PLANNING APPLICATION PLN-21-0151

2 GIBBET HILL RISE, PERTH

ATTACHMENTS

Additional Information Required for Planning Application PLN-21-0151 - 3 Lot Subdivision at 2 Gibbet Hill Rise, Perth

Figure 1 Proposal plan

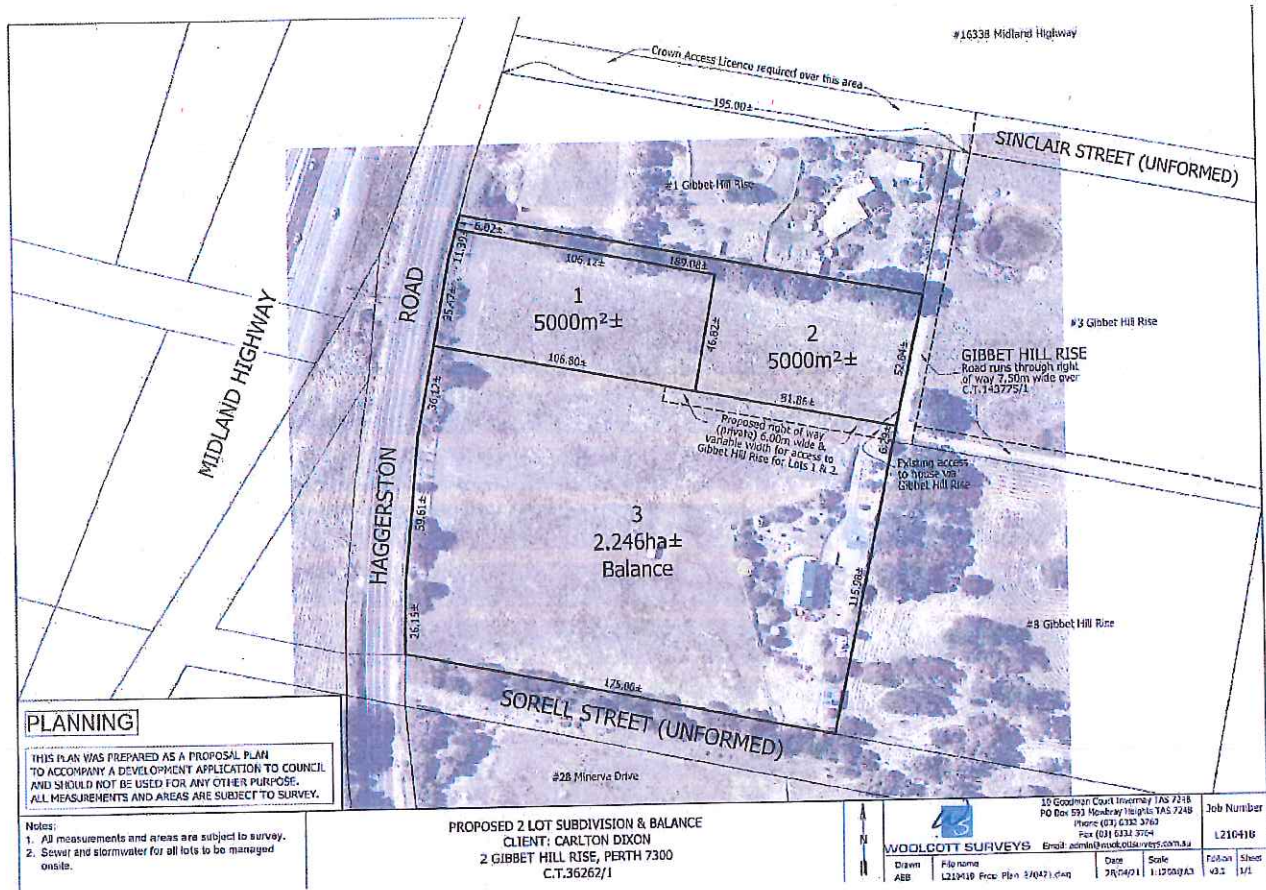
- Traffic Impact Assessment as required by clause E4.5.1 of the Road and Railway Assets Code, to demonstrate compliance with E4.6.1 P3 and updated planning submission report.

The code applies due to the intensification of more than 10% of the existing access point at Haggerstone Road (Crown Land/private access beyond this point) which an inspection has determined is a 70km/h section of road (not 60km/h as referenced in the planning submission).

Haggerston Road has a posted speed limit of 70 km/h as advised by Council. Clause E4.6.1-A3 of the Northern Midlands Interim Planning Scheme 2013 applies which states:

The alignment of Haggerston Road is relatively straight on the southbound approach to the intersection, and the road has a gentle bend on the northbound approach to the intersection. There is a minor crest to the north, however this does not impact on visibility. Vegetation is set back from the roadway such that sight lines are relatively unaffected. The available sight distance exceeds 250 metres in both directions, satisfying Planning Scheme requirements for up to 100 km/h.

This Traffic Impact Statement has assessed the proposed subdivision at 2 Gibbet Hill Rise, Perth, against Clause E4.6.1 of the *Northern Midlands Interim Planning Scheme 2013*. On the basis of the advice provided in this letter, it is considered that the proposal is consistent with Clause E4.6.1-P3.

☐ - OUR PROPERTY - 1 GIBBET HILL RISE

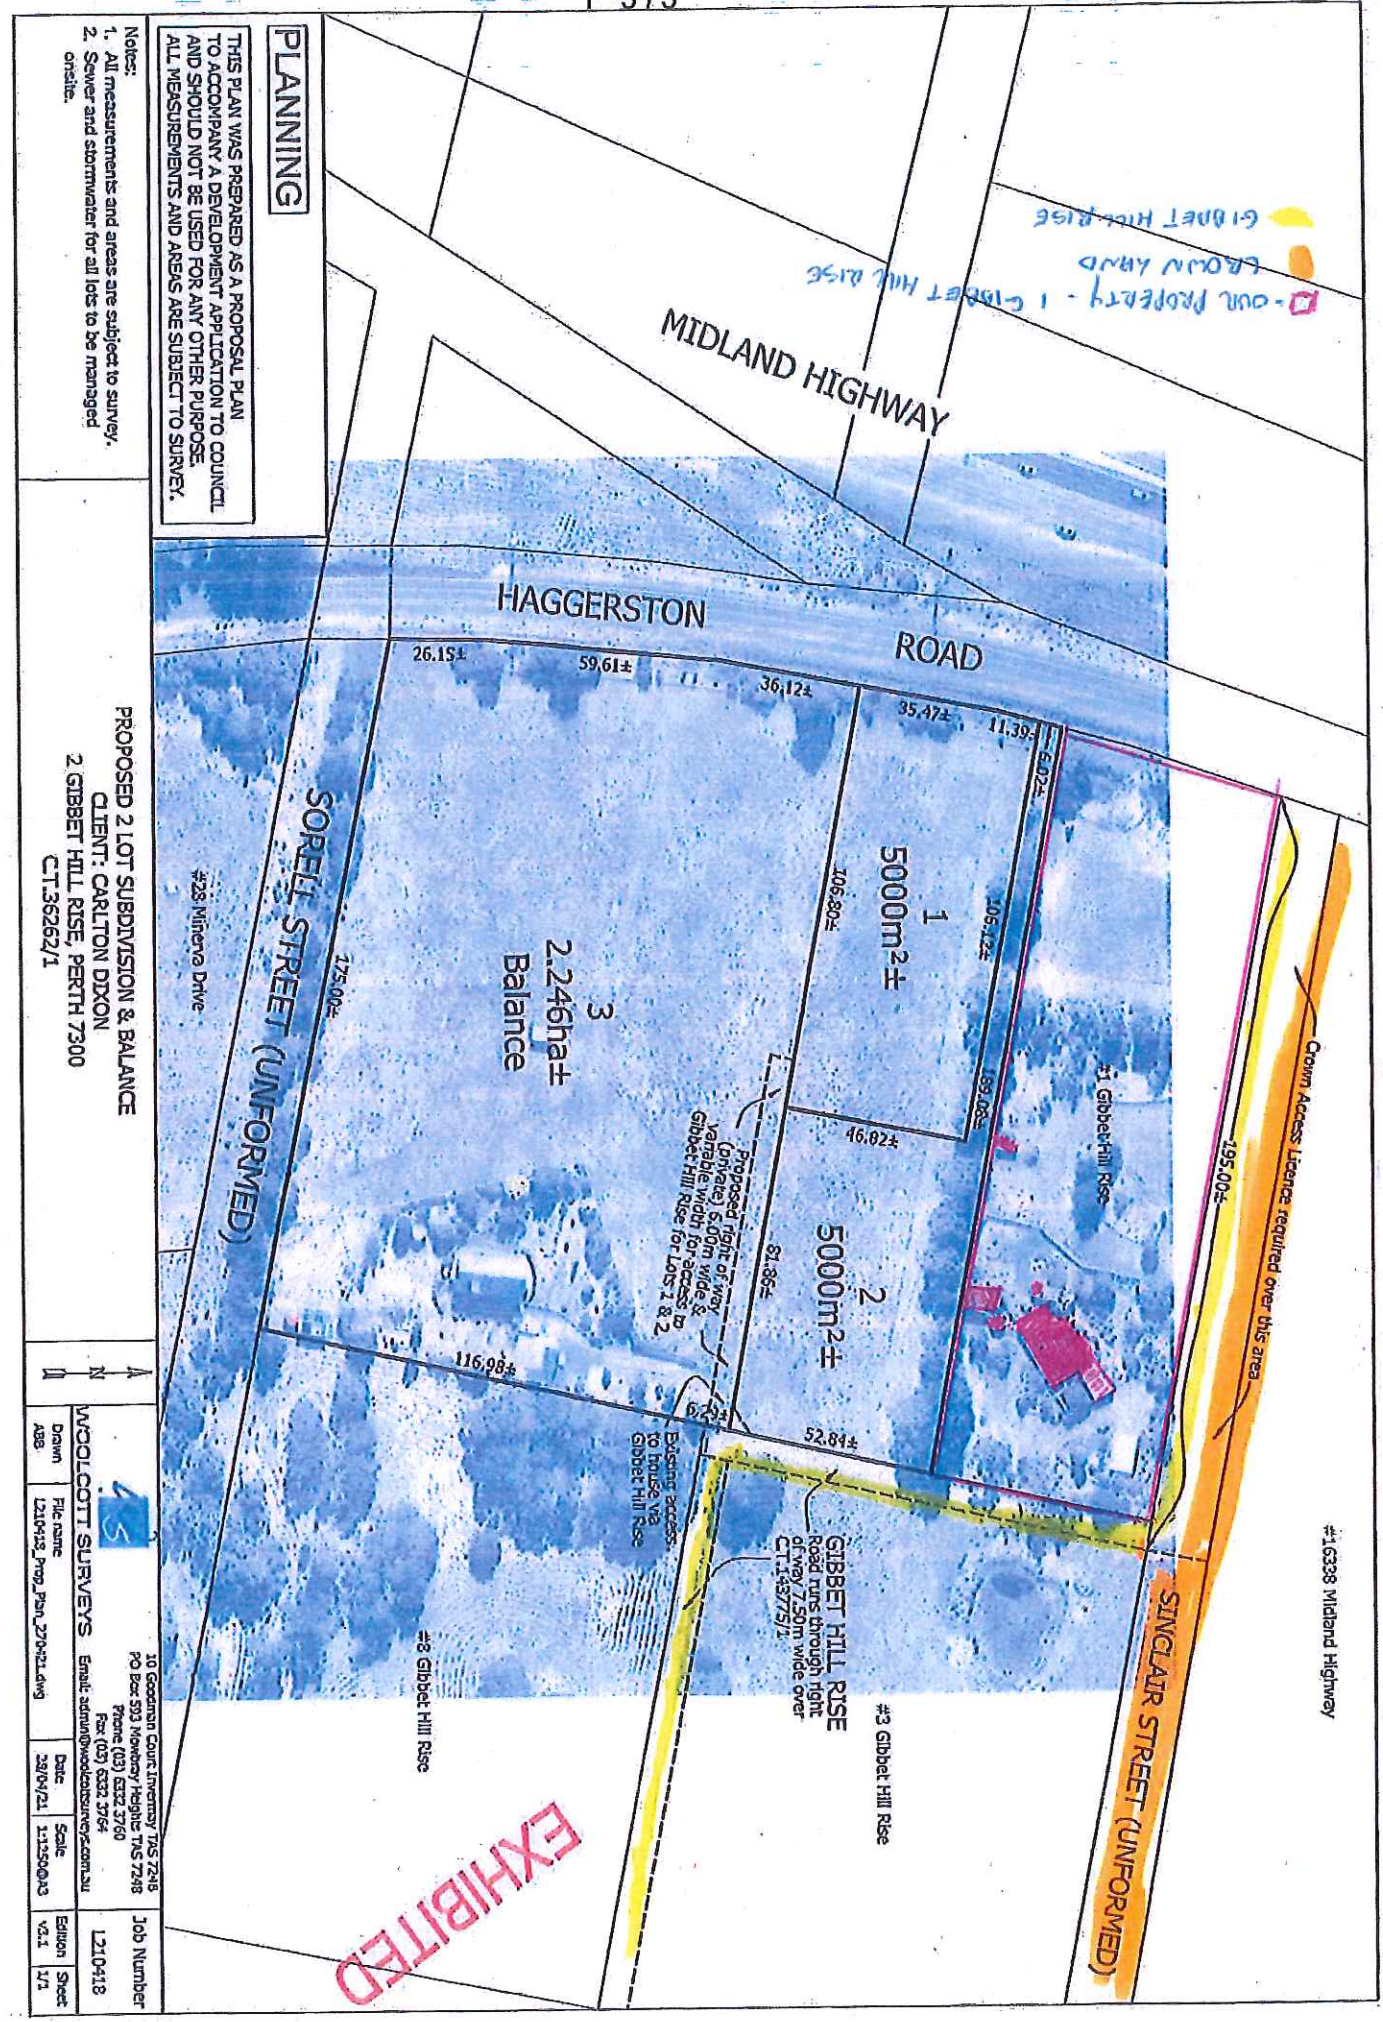
As mentioned in the proposal, there is a line of mature trees along the border of numbers 1 and 2 Gibbet Hill Rise (refer attachment 2). The trees are planted on 2 Gibbet Hill Rise's land, and a substantial fence was built on the property by the previous owner to protect the trees from his live stock. Should the proposed subdivision be accepted in its present, or another form, we request that part of the conditions be that these trees and the fence be retained as a buffer between our two properties. This tree-line is not a hedge as such, has significant gaps in it, and therefore does not provide absolute privacy between our property and 2 Gibbet Hill Rise. Nor is it a noise barrier.

I note that there are no issues raised in the reps that have any merit under the provisions of the Planning Scheme. Each of the lots are provided with the required road frontage and access is via Crown licence over a reserved road and a right of way as is the case with other lots in the immediate surrounds.
